**ZONING AND PLATTING COMMISSISON SITE PLAN
CONDITIONAL USE PERMIT
REVIEW SHEET**

CASE NUMBER: SPC-2011-0217C **ZONING AND PLATTING COMMISSION
HEARING DATE:** December 20, 2011

PROJECT NAME: Lakeline Market

CITY OF AUSTIN – PLANNING AND DEVELOPMENT REVIEW DEPARTMENT
SITE PLAN APPLICATION – MASTER COMMENT REPORT

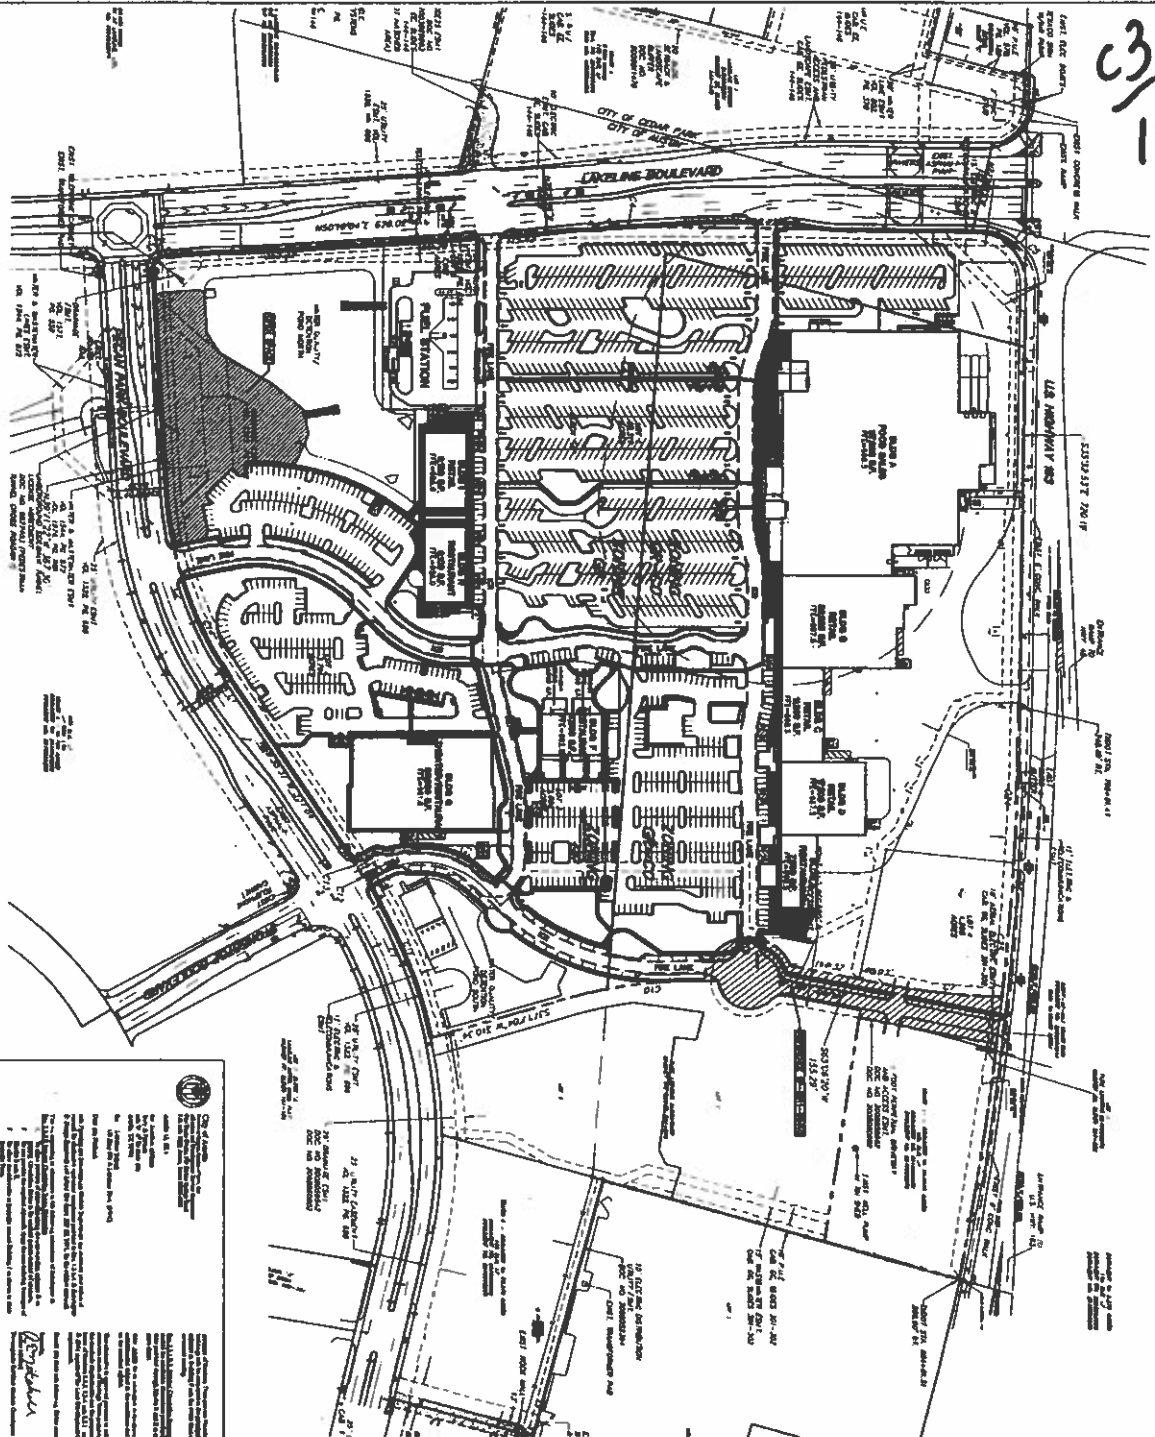
You are requesting an alternative to the following subsections of *Subchapter E: Sec. 2.2.5.B Internal Circulation Route Sidewalks*:

1. To allow portions of sidewalks along the non-building frontage of an Internal Circulation Route to be crushed granite instead of concrete,
2. To not provide the required sidewalk along the non-building frontages of Blocks B and E,
3. To allow the sidewalks to meander around Building F as shown to avoid Heritage Trees,
4. To use an alternative sidewalk along the building frontages of Blocks A and D: A clear zone of 10' – 17' with no planting zone. A minimum 6' awning along 50% of the building frontage will be provided in lieu of trees 30' on center in addition to the preservation of trees as shown on the concept plan.

The site's use of crushed granite on one side of an ICR does not reduce the site's connectivity or compliance with ADA requirements. The alternative sidewalk design is acceptable; the additional sidewalk width and shading achieves the intent of the requirement. In lieu of sidewalks along the north sides of Blocks B and E, crushed granite sidewalks through the parking lots will provide pedestrian refuge and connectivity to the buildings in Blocks A and D.

Your request for an alternative to the above subsections in *Subchapter E* is recommended subject to the conditions that are described above and as demonstrated on the attached exhibit.

MASTER SITE PLAN

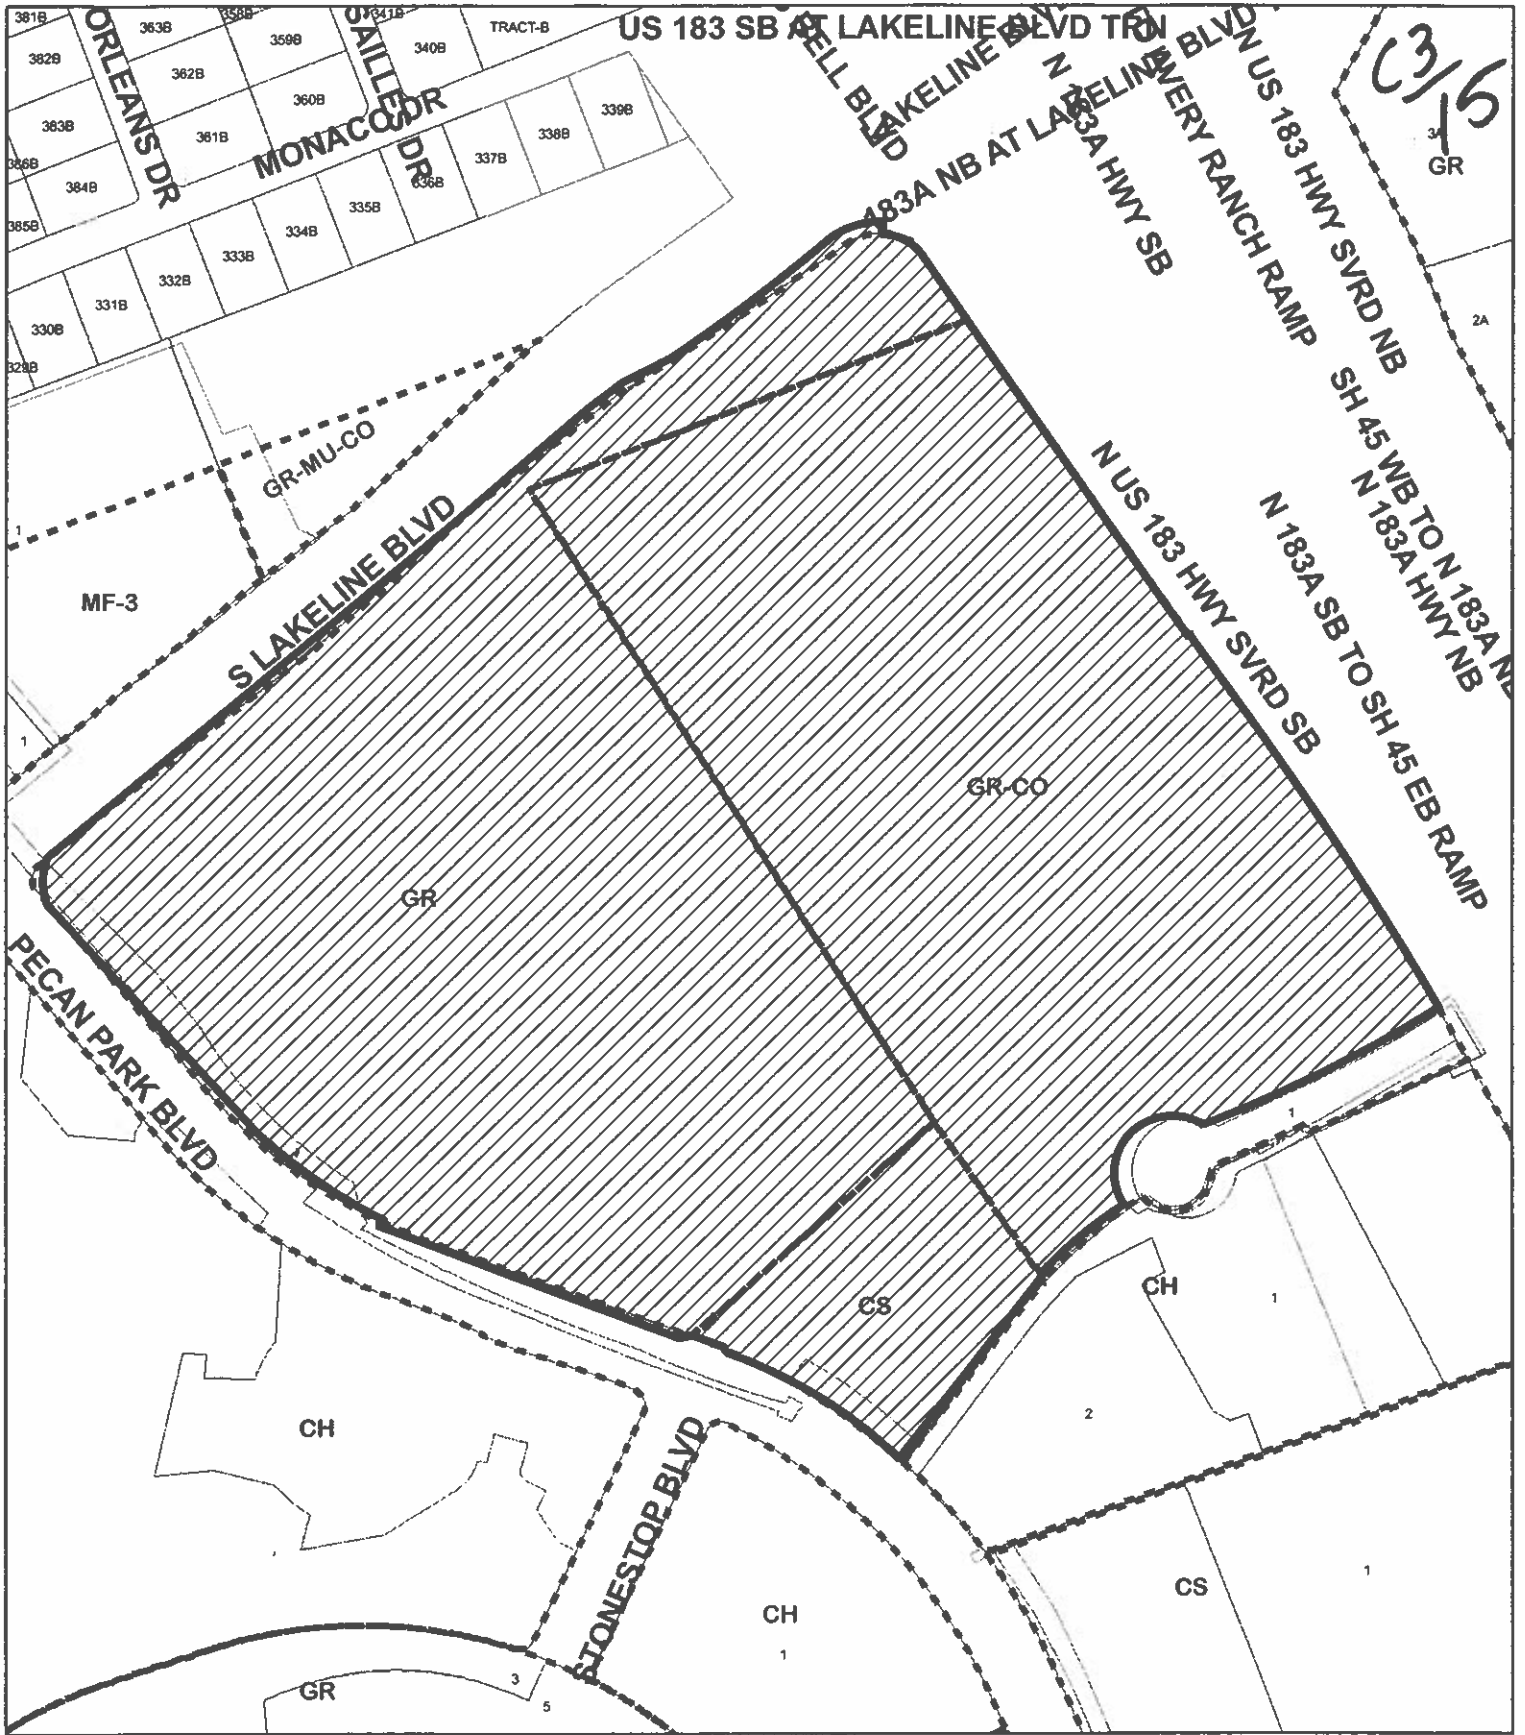
SP 24. Note on the cover sheet and site plan sheet: "The site is composed of 5 lots/tracts. It has been approved as one cohesive development. If portions of the lots/tracts are sold, application for subdivision and site plan approval may be required. Once recorded add the document number for the UDA to the note."

The current note on the cover sheet states 2 lots instead of 5.

- HT 9 Please provide a detailed transplanting plan for the two transplants.
- HT 10 Please include the transplant sheets as dedicated sheets in the plans.
- HT 11 Grade line 955 needs to be removed from 1/2 crz of tree 8796 and possibly 8792.
- HT 12 Remove the two parking spaces around tree 8742.
- HT 13 Grade line 853 and 854 need to avoid 1/2 CRZ of tree 8959.
- HT 14 Reroute 18" line outside of 1/2 crz of tree 8618. Preferably relocate the line into area that is to be disturbed for the road.
